ATTACHMENT 3

REVISED RADIOLOGICAL EMERGENCY PLAN ANNEX INFORMATION

BYRON STATION

EP-AA-1002

RECOGNITION CATEGORY
FISSION PRODUCT BARRIER DEGRADATION
Figure 3-F-1: PWR Containment Integrity or Bypass Examples

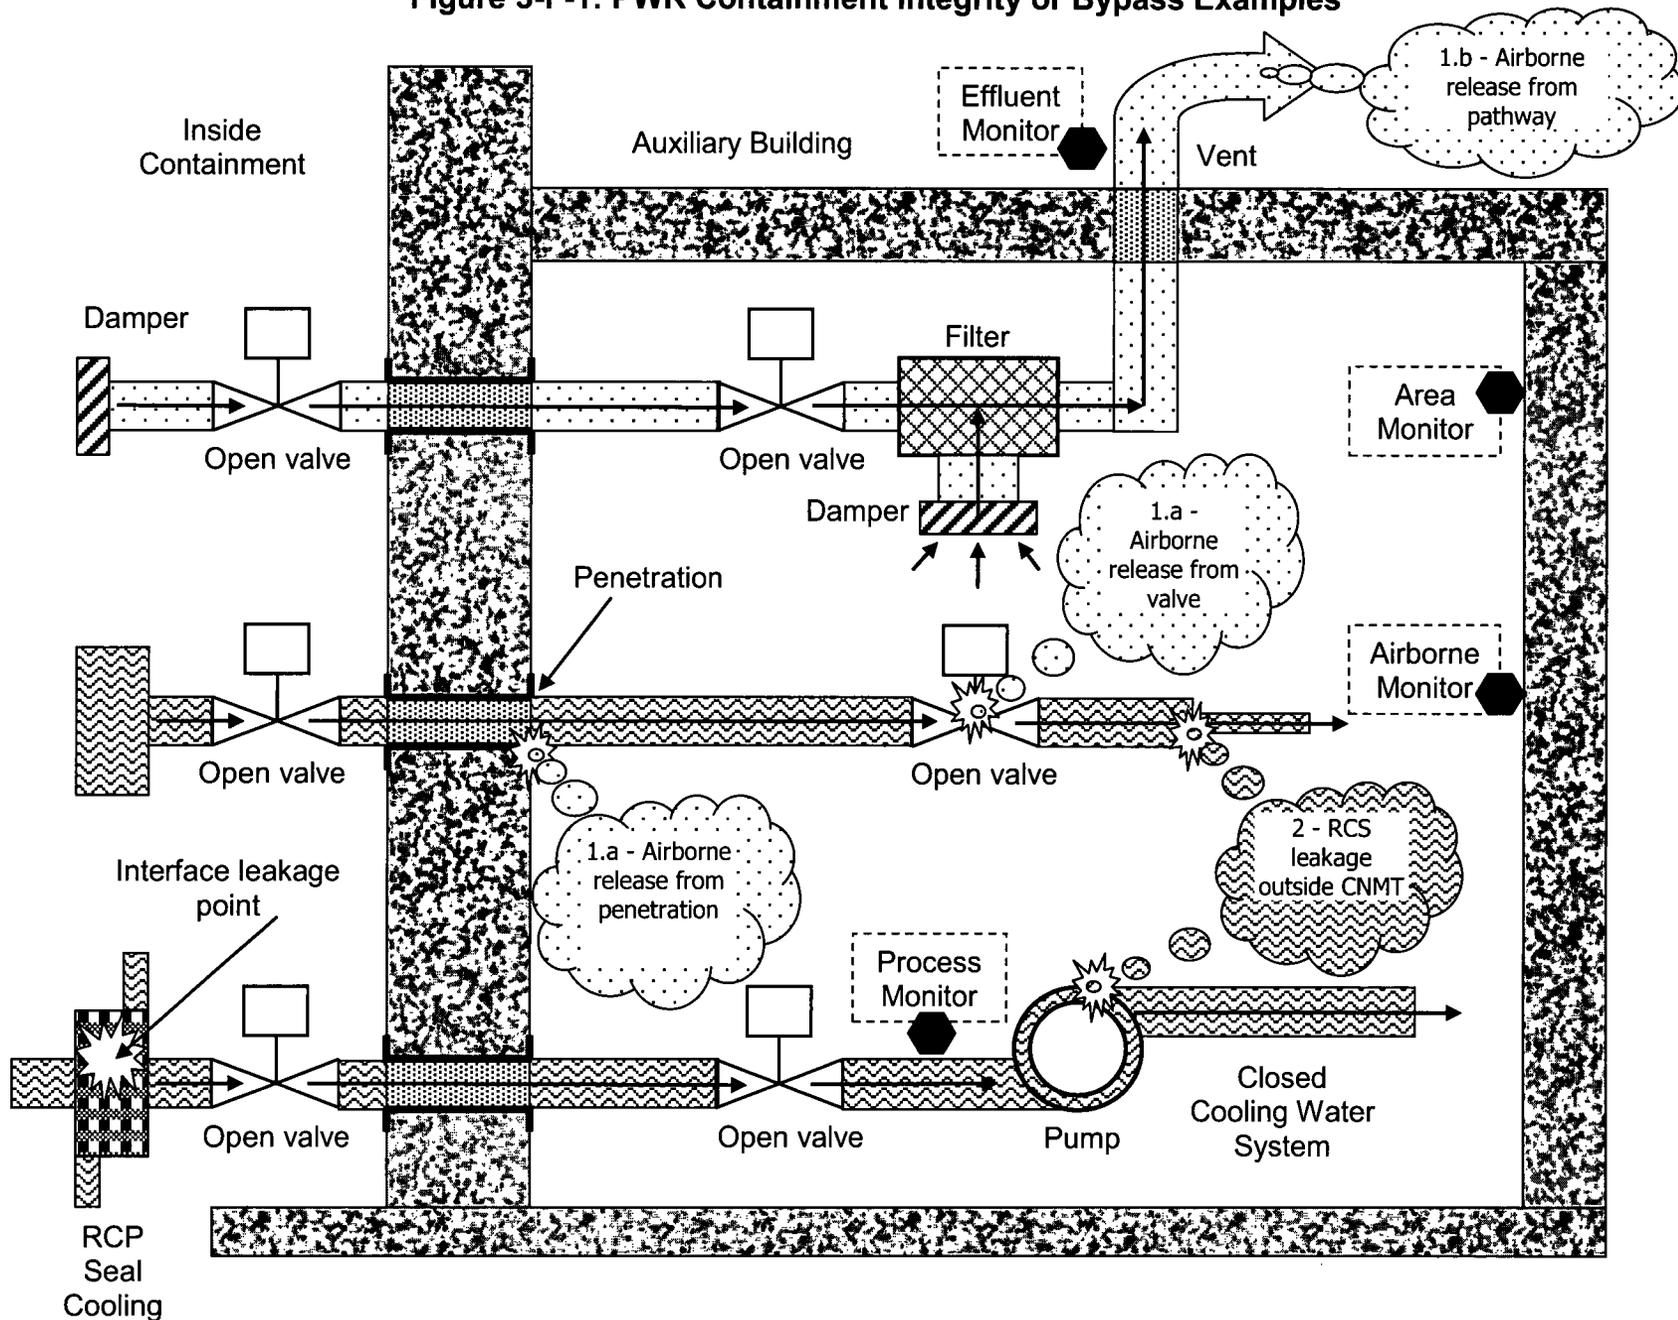
Refer to the middle piping run of Figure 3-F-1. Two simplified examples are provided. One is leakage from a penetration and the other is leakage from an in-service system valve. Depending upon radiation monitor locations and sensitivities, the leakage could be detected by any of the four monitors depicted in the figure.

Refer to the top piping run of Figure 3-F-1. In this simplified example, the inboard and outboard isolation valves remained open after a containment isolation was required (i.e., containment isolation was not successful). There is now an UNISOLABLE pathway from the containment to the environment.

Leakage between two interfacing liquid systems, by itself, does not meet this threshold. Refer to the bottom piping run of Figure 3-F-1. In this simplified example, leakage in an RCP seal cooler is allowing radioactive material to enter the Auxiliary Building. The radioactivity would be detected by the Process Monitor. If there is no leakage from the closed water cooling system to the Auxiliary Building, then no threshold has been met. If the pump or system piping developed a leak that allowed steam/water to enter the Auxiliary Building, then loss threshold 2 would be met. Depending upon radiation monitor locations and sensitivities, this leakage could be detected by any of the four monitors depicted in the figure and cause threshold 1.a to be met as well.

Refer to the middle piping run of Figure 3-F-1. In this simplified example, a leak has occurred at a reducer on a pipe carrying reactor coolant in the Auxiliary Building. Depending upon radiation monitor locations and sensitivities, the leakage could be detected by any of the four monitors depicted in the figure and cause loss threshold 1.a to be met as well.

RECOGNITION CATEGORY
FISSION PRODUCT BARRIER DEGRADATION
Figure 3-F-1: PWR Containment Integrity or Bypass Examples

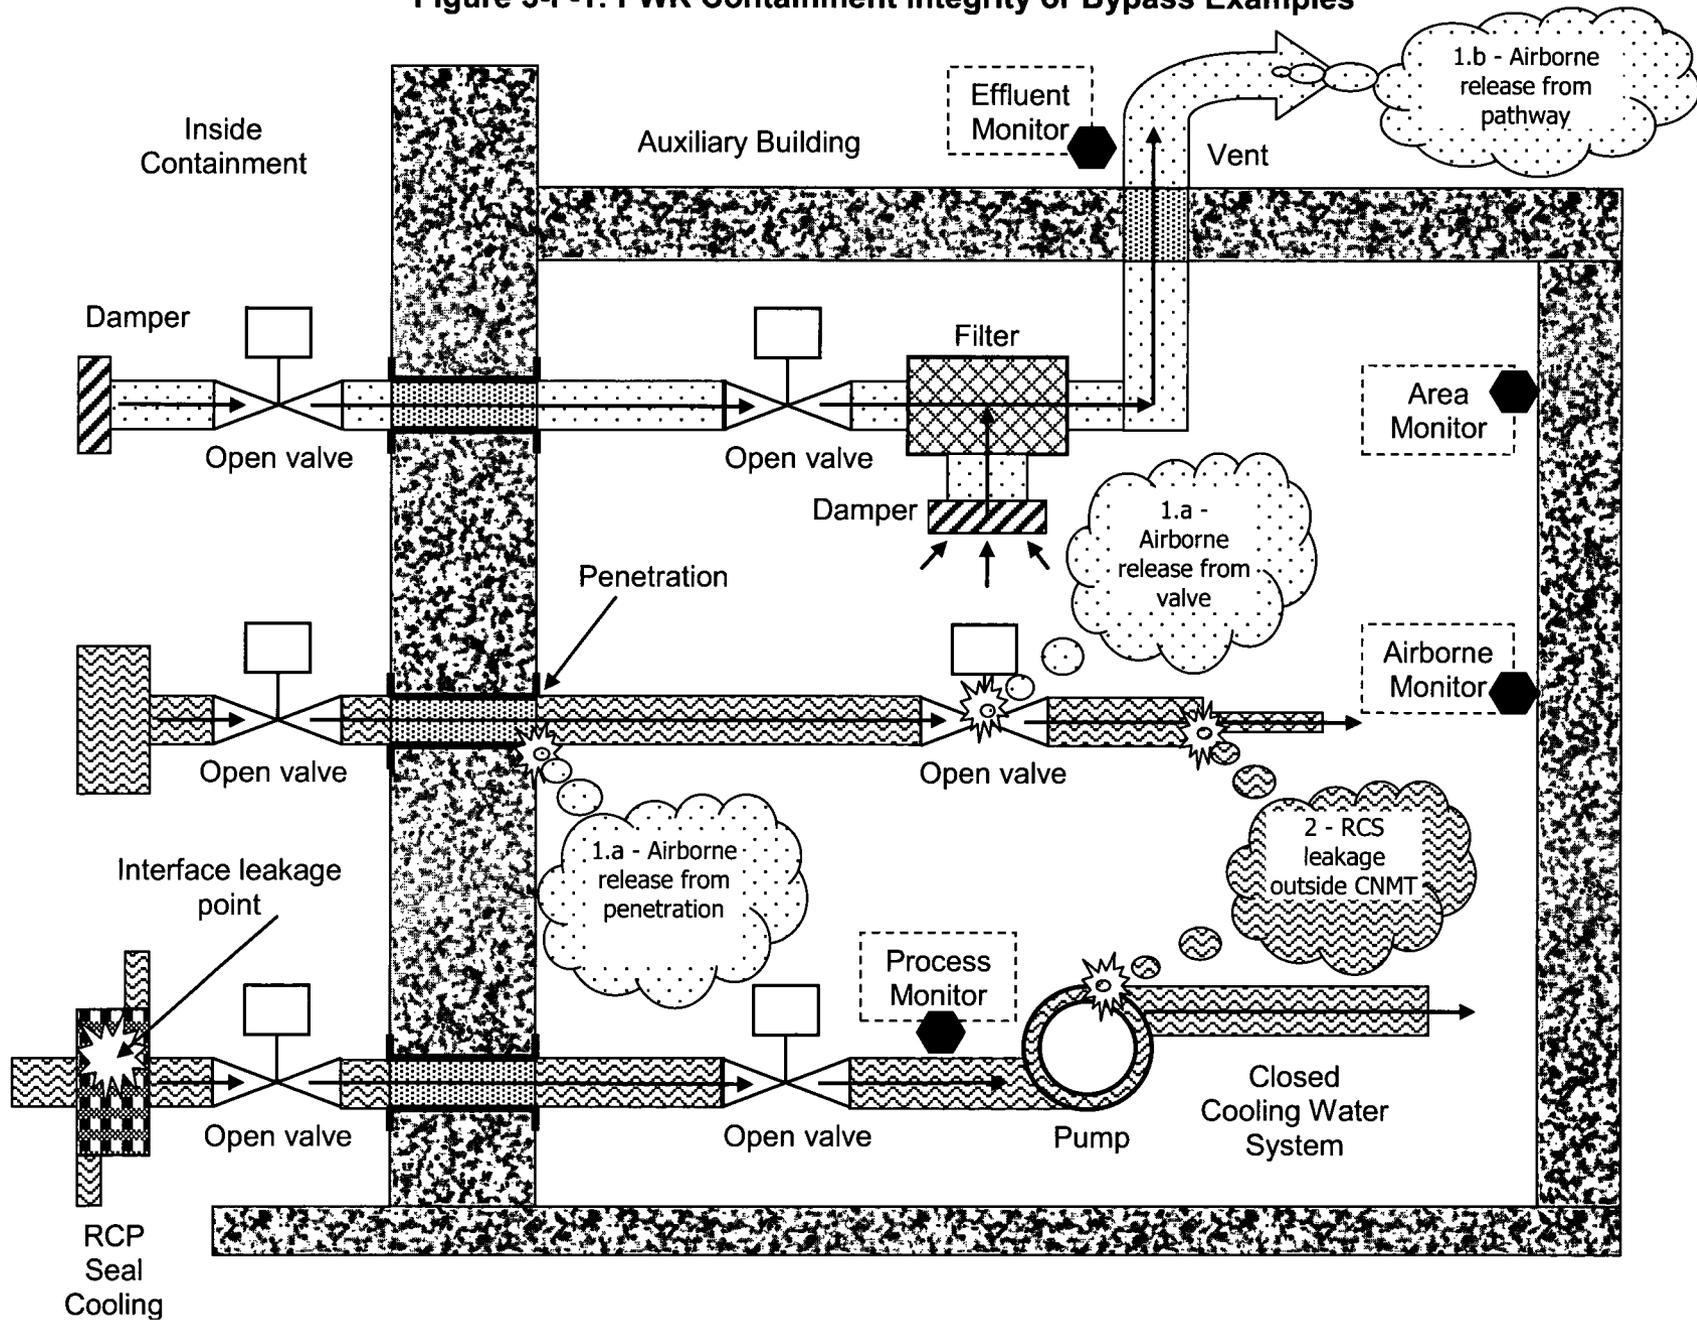
Refer to the middle piping run of Figure 3-F-1. Two simplified examples are provided. One is leakage from a penetration and the other is leakage from an in-service system valve. Depending upon radiation monitor locations and sensitivities, the leakage could be detected by any of the four monitors depicted in the figure.

Refer to the top piping run of Figure 3-F-1. In this simplified example, the inboard and outboard isolation valves remained open after a containment isolation was required (i.e., containment isolation was not successful). There is now an UNISOLABLE pathway from the containment to the environment.

Leakage between two interfacing liquid systems, by itself, does not meet this threshold. Refer to the bottom piping run of Figure 3-F-1. In this simplified example, leakage in an RCP seal cooler is allowing radioactive material to enter the Auxiliary Building. The radioactivity would be detected by the Process Monitor. If there is no leakage from the closed water cooling system to the Auxiliary Building, then no threshold has been met. If the pump or system piping developed a leak that allowed steam/water to enter the Auxiliary Building, then loss threshold 2 would be met. Depending upon radiation monitor locations and sensitivities, this leakage could be detected by any of the four monitors depicted in the figure and cause threshold 1.a to be met as well.

Refer to the middle piping run of Figure 3-F-1. In this simplified example, a leak has occurred at a reducer on a pipe carrying reactor coolant in the Auxiliary Building. Depending upon radiation monitor locations and sensitivities, the leakage could be detected by any of the four monitors depicted in the figure and cause loss threshold 1.a to be met as well.
